**SITE PLAN REVIEW SHEET  
ENVIRONMENTAL VARIANCE REQUEST ONLY**

**CASE:** SP-2019-0109C(R1)

**PROJECT NAME:** Water Oak Apartments

Request to vary from LDC 25-8-342 to allow fill to 25 feet to construct a driveway.

Three Hills Land LLC  
**THREE HILLS APARTMENTS - PHASE ONE**  
**CUTFILL EXHIBIT**

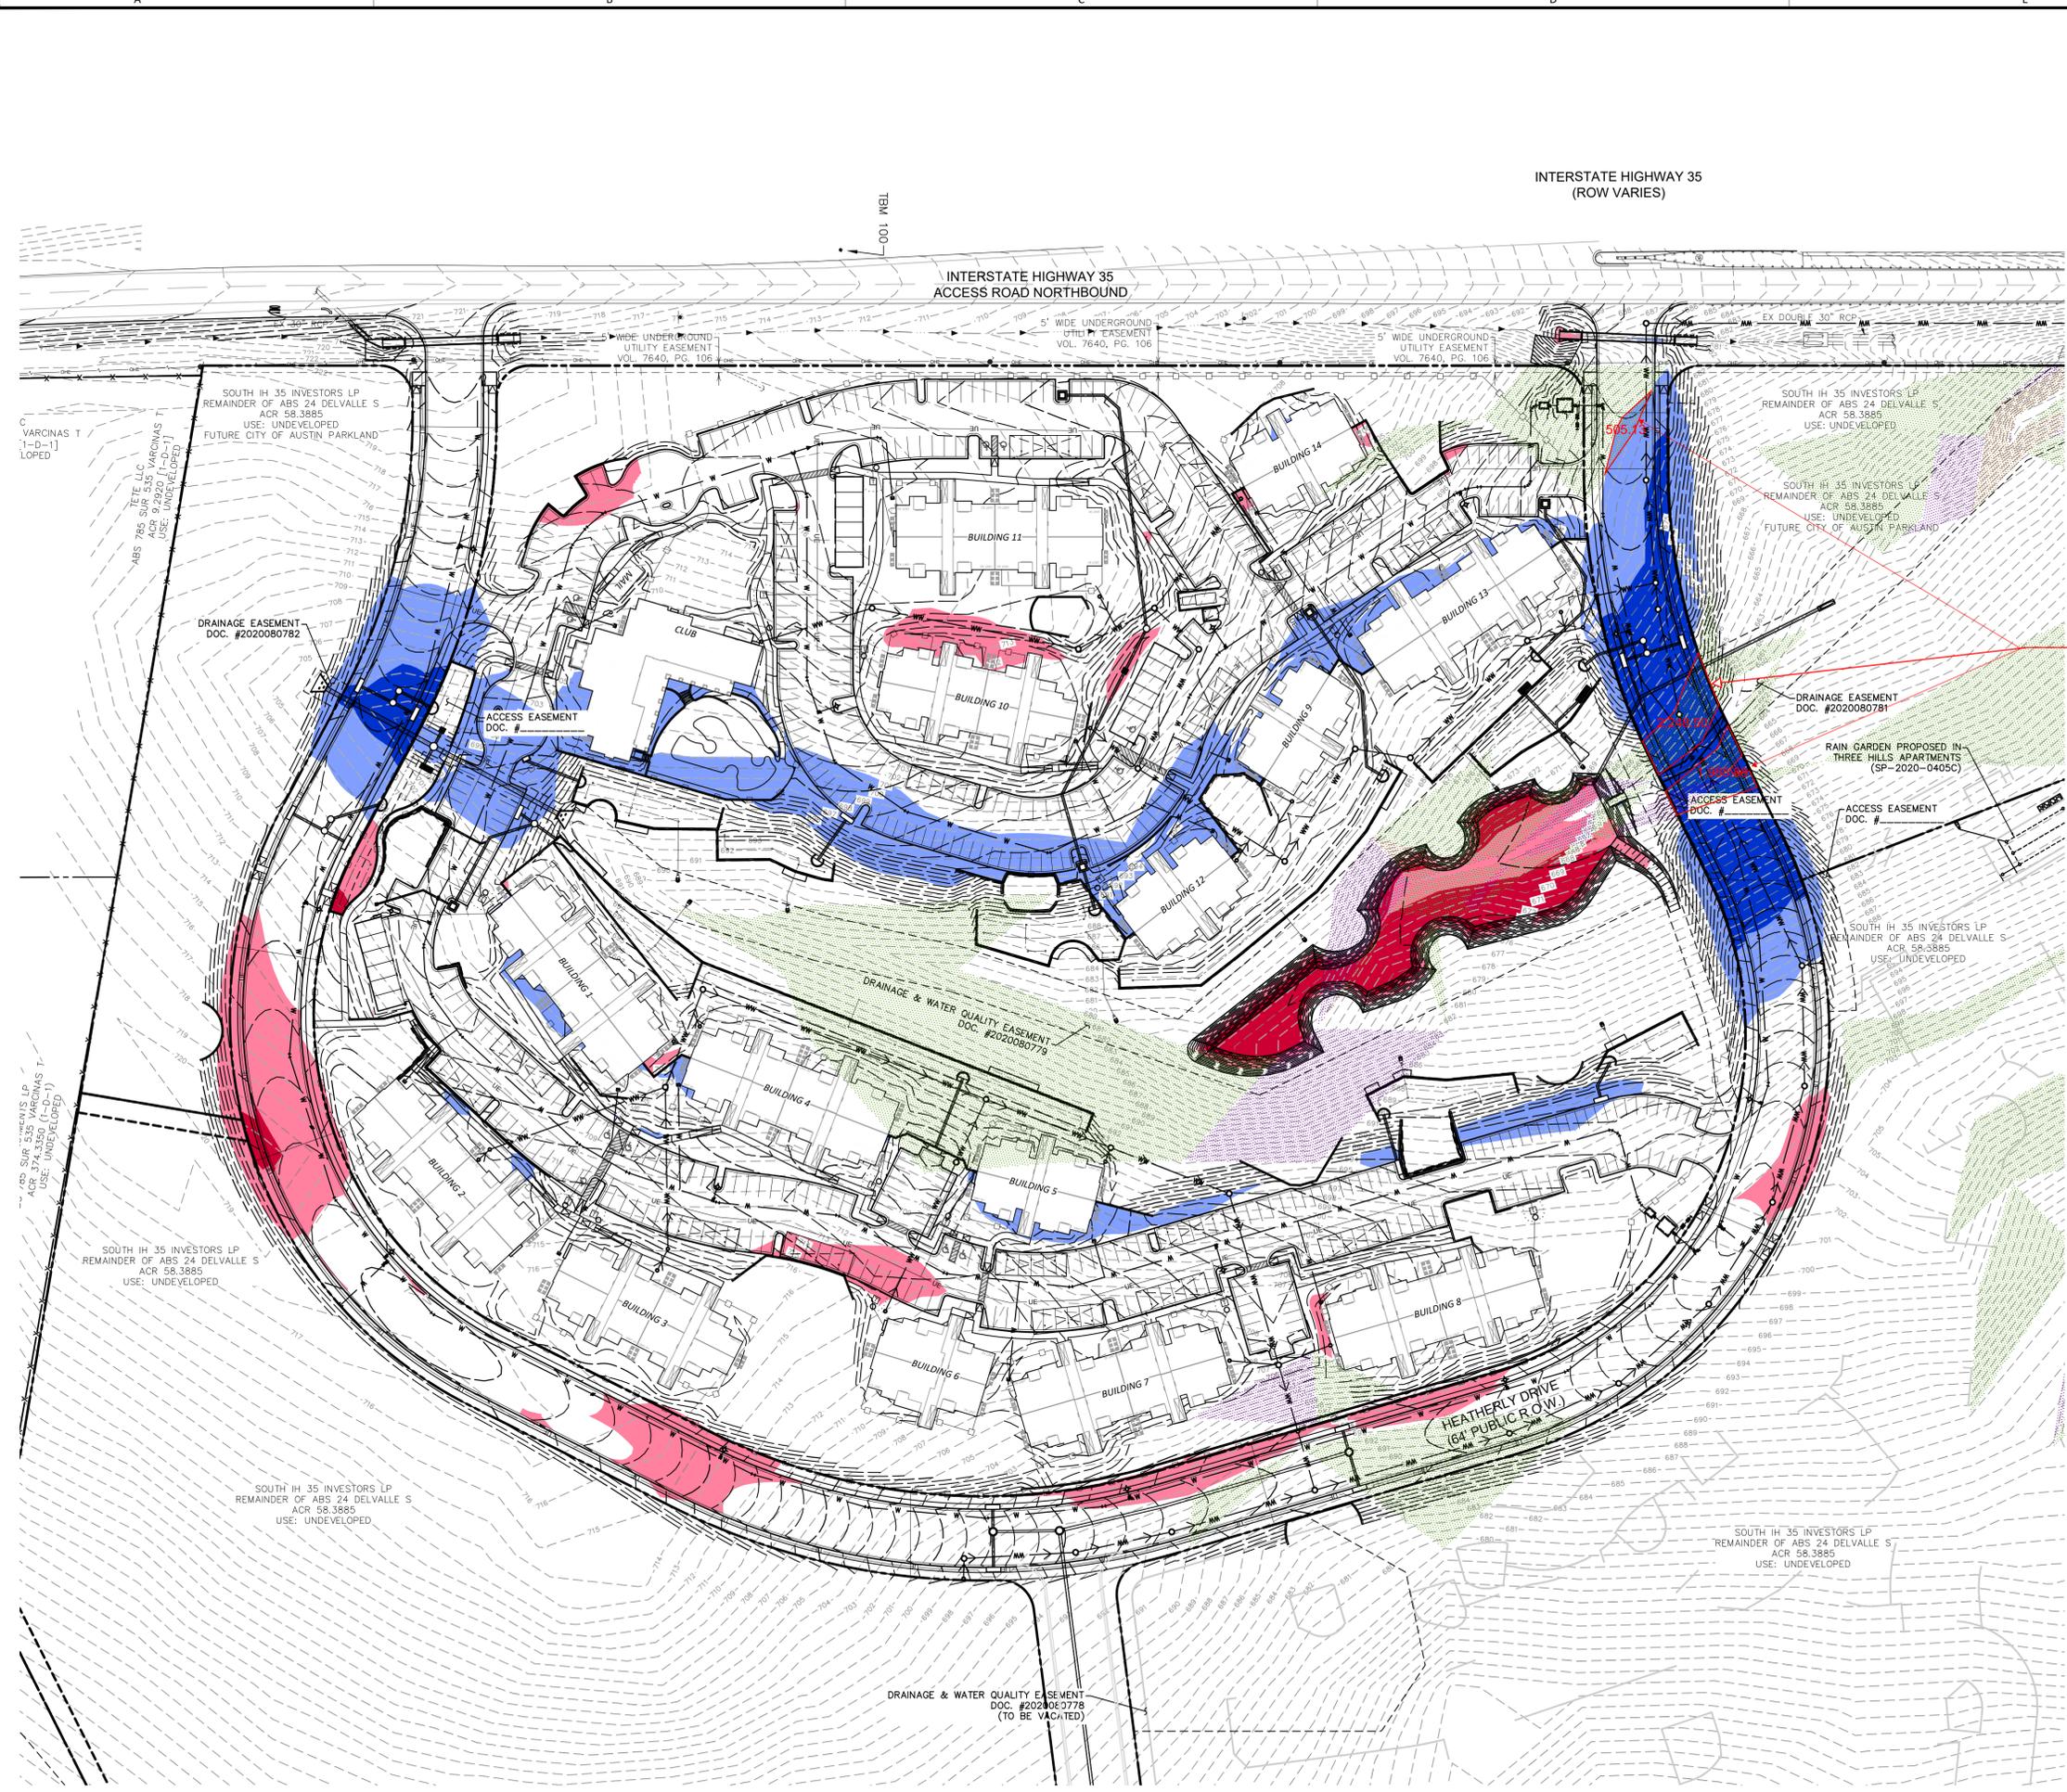
No The variance is necessitated by the construction method chosen by the applicant. The depth and quantity of fill is due to the applicant's decision to fill rather than span the more than twenty (20) feet of grade change of the swale.

Yes / No      We are only requesting fill over 4 feet on 15% or greater slopes on 0.11 acres or approximately 2.2% of the total public/private roadway area.

0.11 Acres Fill  
Over 4' in 15%  
Slope Zone
